Sound Wall at Festival Beach

Staff Briefing

Parks and Recreation Board, July 22nd, 2024

**WALL PLAN & PROFILE
SOUND WALL 01B**

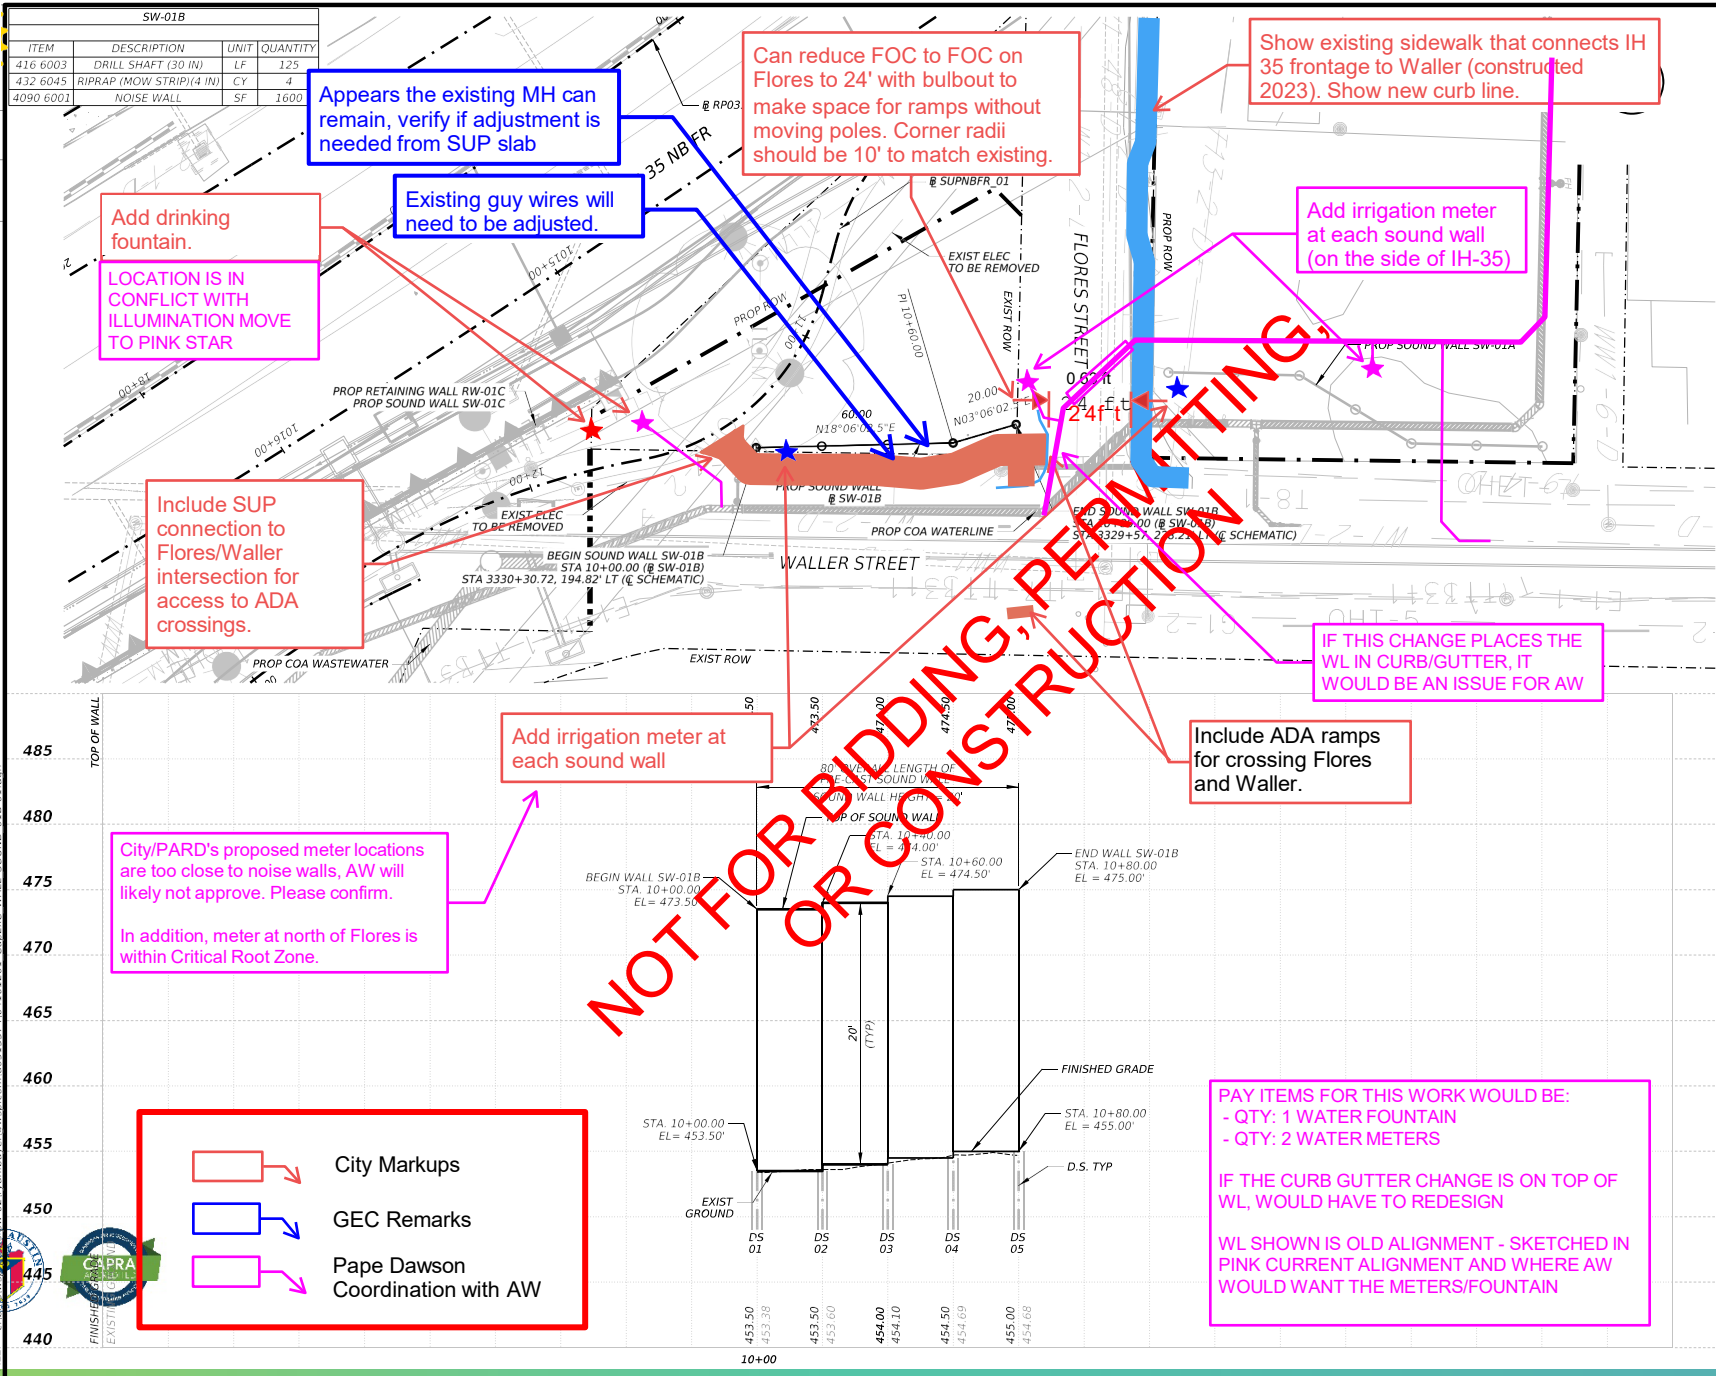
City Markups

GEC Remarks

Pape Dawson Coordination with AW

IF THE CURB GUTTER CHANGE IS ON TOP OF WL, WOULD HAVE TO REDESIGN

WL SHOWN IS OLD ALIGNMENT - SKETCHED IN PINK CURRENT ALIGNMENT AND WHERE AW WOULD WANT THE METERS/FOUNTAIN

PAY ITEMS FOR THIS WORK WOULD BE:

- QTY: 1 WATER FOUNTAIN
- QTY: 2 WATER METERS
